## FCC Core Group Meeting Minutes

Fresno CC Science Bldg  
10/19/2018

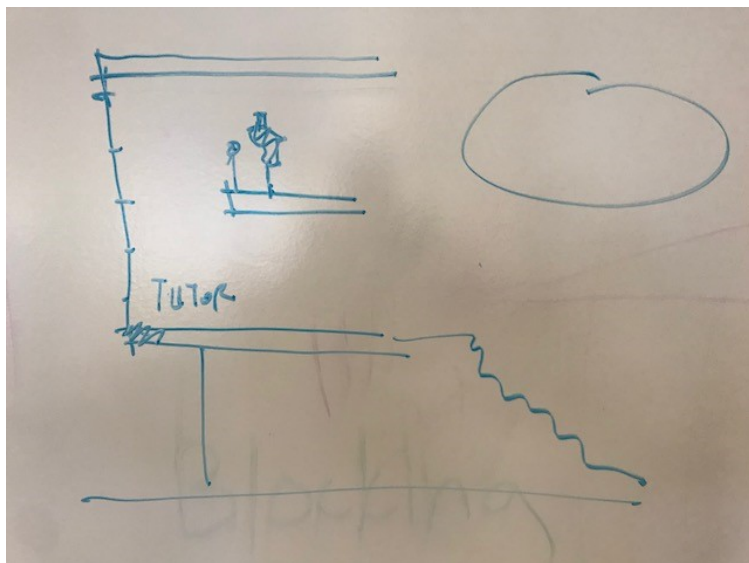
Jonathan and Aaron presented the revised floor plans options, see attached. Preferred 2nd and 3rd floor plans are indicated within a red box. Specifically, the group confirmed:

- There is no value in having lecture rooms in the middle of the building on the 2<sup>nd</sup> and 3<sup>rd</sup> floors.
- Large lecture must be on the first floor
- Do not like the disruption at the prep spaces from south 3<sup>rd</sup> stair.
  - Would like to see an option of 3rd stair on north side of building
- Tutor area does not need a closed “office” can be open or have small breakout conference rooms.
- Move the Tutor space moving to second floor
- Liked the idea of a large open space between the 2nd and 3rd floor (see sketch below) pending a rendering.

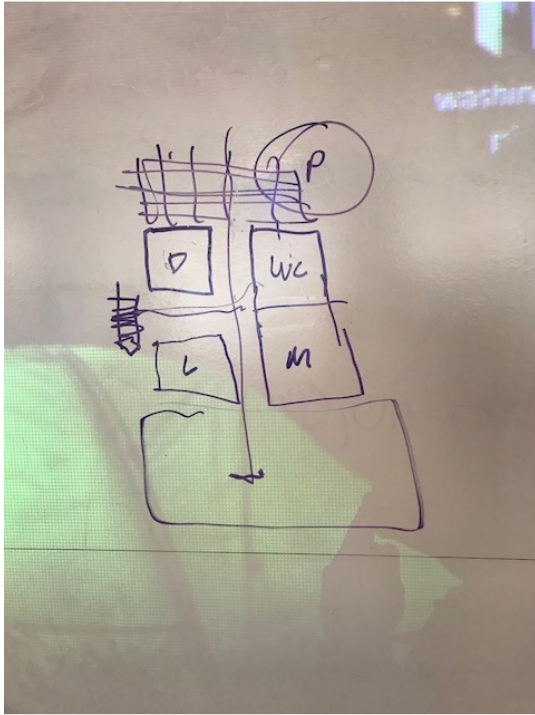
- Computer lab can be a “glass box” should be able to seat 36 or more. Computer lab should be a closeable and lockable space.
- The two lecture halls on second floor should be equally sized.
- The group discussed what the Welcome Center should be. It was generally agreed that instead of a closed “office” with cubicles and a help counter, it should be an open space near the north end of the building. It should accommodate student gathering, both formal and informal.
- The group agreed on the arrangement of the Museum, Welcome Center, Dean’s Office and Large lecture per the sketch (not to scale) below. See next page.

- The connection to both a north plaza and a shaded south plaza should be open and welcoming with the ability to enter either south or north end and walk all the way through the first floor. The west interior stair should also connect the first floor and the second floor.
